DEFORE THE PUBLIC UTILITY COMMISSION OF OREGON

Docket No. LC 74

2019 Integrated Resource Plan.

Staff's Final Comments

Figure 1 - Idaho Power Load Forecasts in Previous IRPs

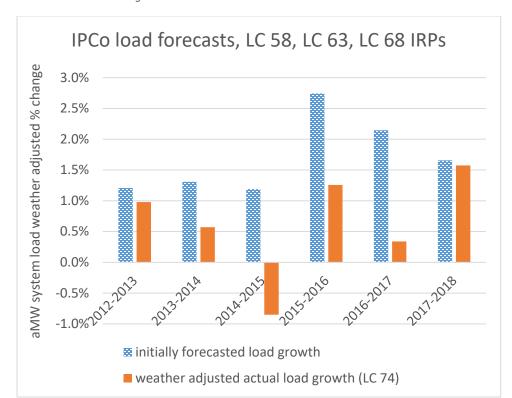
Staff investigated STOP B2H's concern that a simpler model should be used for load forecasting. Staff agrees with the Company that econometric models that account for factors impacting load growth are the industry standard and the best method to perform load forecasts. However, Staff also agrees with STOP B2H that the Company should do a better job describing why its models have been inaccurate in the past and how it plans to improve in the future. *Figure 1* on the following page shows forecasted load growth in LC 58, LC 63, and LC 68 versus the actual weather-adjusted load growth provided in LC 74:

Figure 3 - Highlighted WECC-Optimized Portfolios

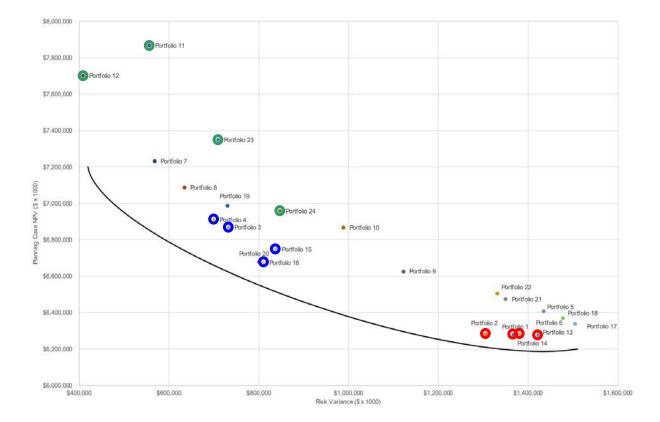
While Staff can understand wanting to distinguish portfolios by forecast category, the differences among portfolios become even less clear as the IRP progresses. Additionally, the initial WECC Portfolios 1, 3, and 11 do not appear to be determined by planning carbon or high carbon forecasts, but rather zero carbon or generational carbon forecasts. It also appears that the Company chose to re-label these for simplicity. Likewise with Portfolios 13, 15, and 23, these appear to be created with zero carbon or generational carbon forecasts, not the Planning or High Carbon forecasts as suggested in the table. It is thus unclear what carbon forecasts are actually used, and whether the portfolios would really perform the same under a zero carbon or generational carbon forecast when considering different Jim Bridger exit dates. Regardless, the portfolios grouped together do appear similar, and the basic idea here is that the Company uses these gas and carbon forecasts to create an initial range of buckets for further analysis.

On the following page is a graph of the initial 24 WECC-optimized portfolios, with the portfolios from *Figure 3* highlighted for ease of reference.

Figure 5 - Ordered Results Across WECC Portfolios

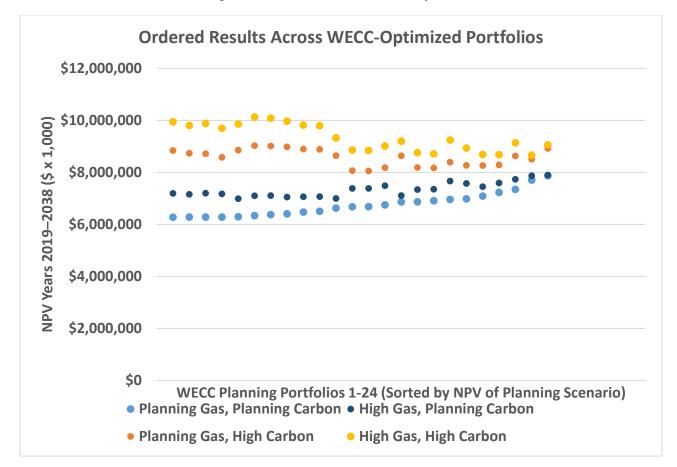
The following chart of the initial WECC-optimized portfolios 1-24 illustrates this point. Each dot represents a portfolio, and each color corresponds to a different planning future. The dots are matched so that a vertical set of four colored dots represents a portfolio across the four different planning futures. For ease of reference, the portfolios are ordered left to right by lowest to highest NPV of the Planning Gas, Planning Carbon future. As the graph demonstrates, the scenarios with the strongest correlation move together.

A result of the Company's approach, the analysis appears to really only look at the difference between planning carbon and high carbon as an indicator of risk.

Figure 1

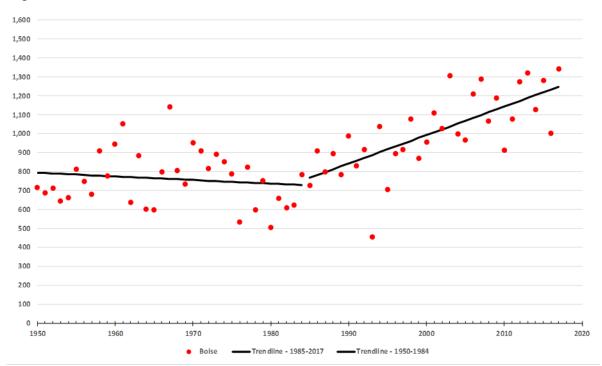
IDAHO POWER COMPANY'S RESPONSE TO STAFF'S INFORMATION REQUEST NO. 63:

The forecasted values of the average peak-day temperature explanatory variable in the Company's monthly peak regressions is static--or assumes temperatures will not change. Using trendline analysis through the historical weighted average peak-day temperatures over the period 1950-2017, a clear hinge was present. This is noted in Figure 1 below. A hinge-fit analysis of weather depicts a steady increase in seasonal CDDs as measured at Boise Weather Station since 1985. Subsequently, linear temperature trend variables were added as explanatory variables in the summertime regression models (Jun, July, and August). These trend variables were added to assist in informing the rising average peak day temperature impact on summertime peak demand. Inclusion of a trend variable increases peak day temperatures for planning on average 0.1%-0.2% per year depending on the month.
